EC70139 REV. 0
ATTACHMENT Z47R0
DWG. NO. 522-041-005

NUCLEAR ENGINEERING
CRYSTAL RIVER UNIT 3
AUXILIARY BUILDING – SOUTH STEEL FRAMING MODIFICATIONS DETAILS

DETAIL 1
SCALE: 1½"=1'-0"
DWG. 522-041-001

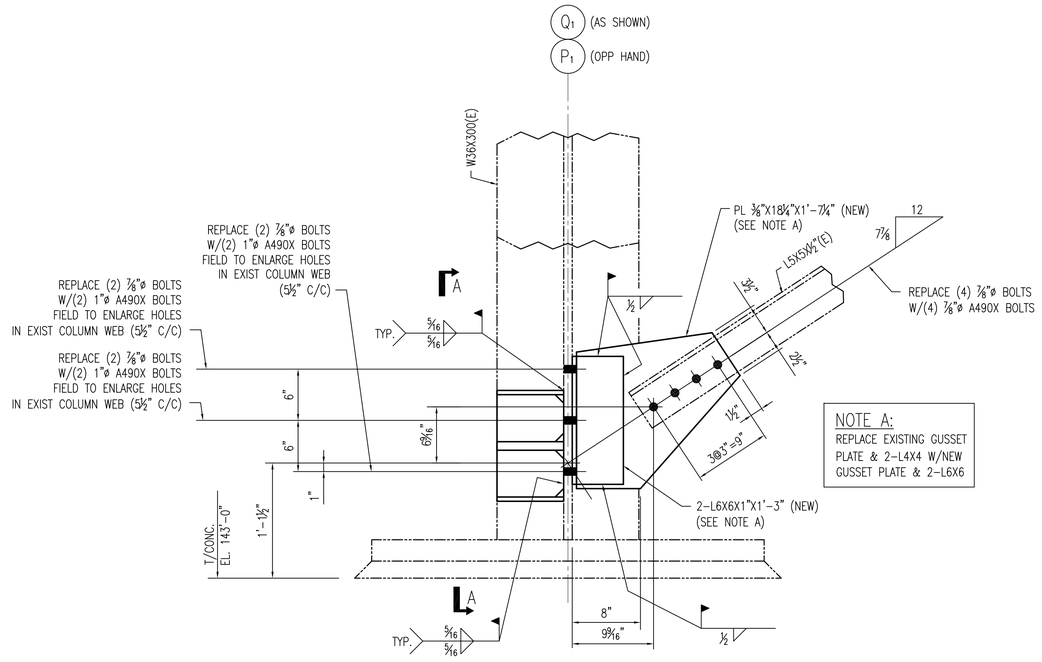
NOTE A:
REPLACE EXISTING GUSSET PLATE & 2-L4X4 W/NEW GUSSET PLATE & 2-L6X6
